## LANDMARKS COMMISSION AGENDA

A. HI-20-25, Type III – Quasi-Judicial Process [Pages 6-30]

# Staff Report

HI-20-25

**4.3. Drawing – West wall and back of building (proposed change highlighted blue)**

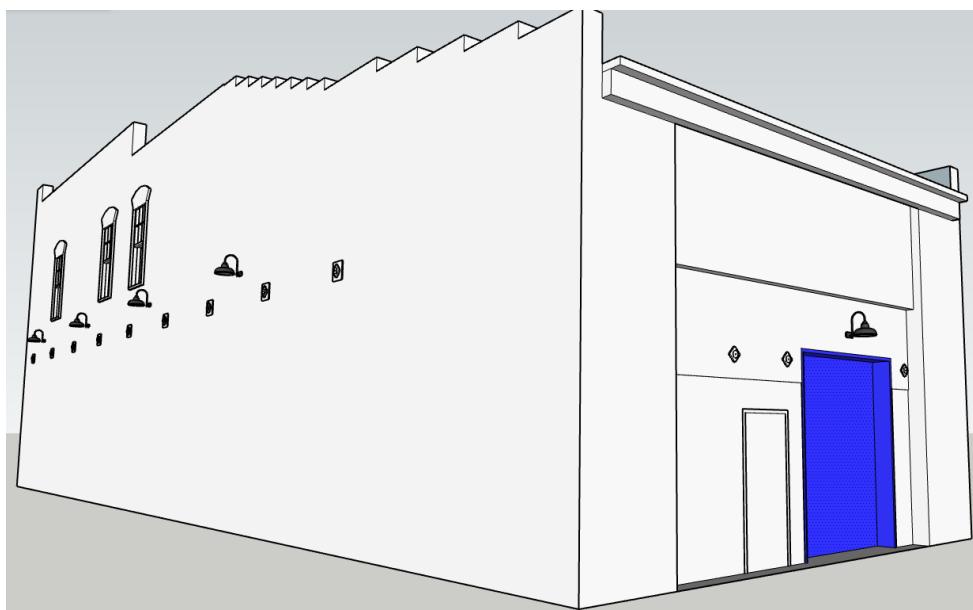
- 1.5 **Proposed Exterior Alterations.** The applicant proposes to increase the size of the garage door opening on the rear of the structure from seven feet to ten feet (Attachment C). This change is proposed in order to support the future commercial use of the building.

1.13 Historic Materials (ADC 7.160(9)). The applicant proposes to enlarge the garage door opening on the rear façade of the structure. The applicant states that the alteration will only affect the building's T1-11 siding, whereas the property's historic significance is characterized by its brick exterior. The work is not anticipated to affect any of the brick exterior.

Condition 1 **Exterior Alterations** – The proposed exterior alterations shall be performed and completed as specified in the staff report and application as submitted. Deviations from these descriptions may require additional review.

**4.4. Drawing – Back of building (proposed change highlighted blue)**

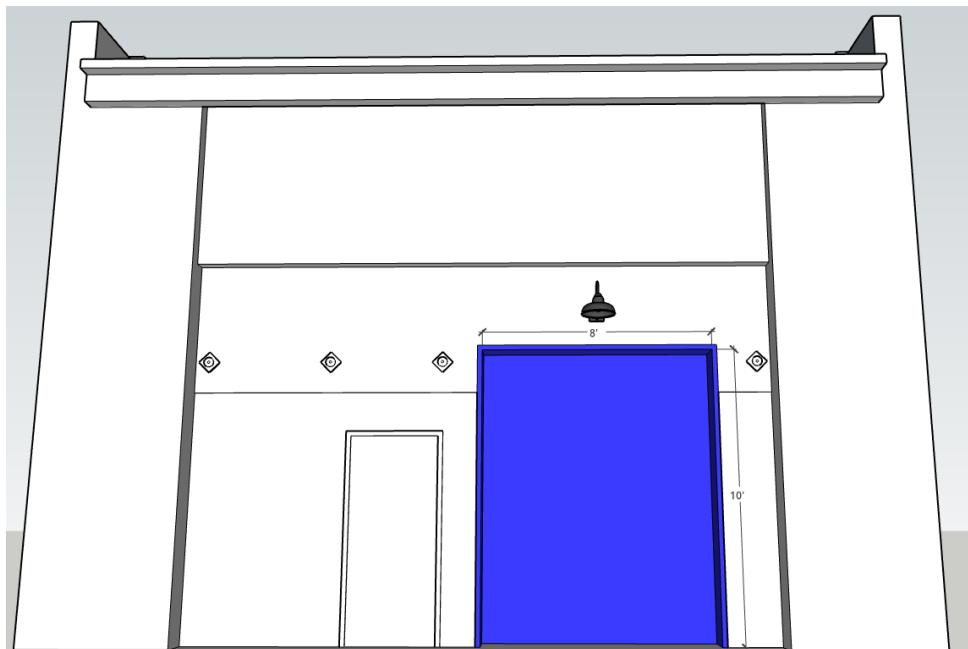
I started working through writing up the staff report for the Schultz building and I realized there weren't any drawings of what the new garage door(s) would look like. Are you planning on doing a roll-up garage door or would it be a larger version of the opening garage doors on the current structure? Sorry to bother you right before Christmas! If you could get back to me by December 30 that would be great, no need to rush.

Here is a brochure I got from the garage door guy when I originally started look at it, its not a roll up, its still an internal track door that will allow for the use of the vertical space on the interior more so than a traditional track garage door you see in a house's garage.
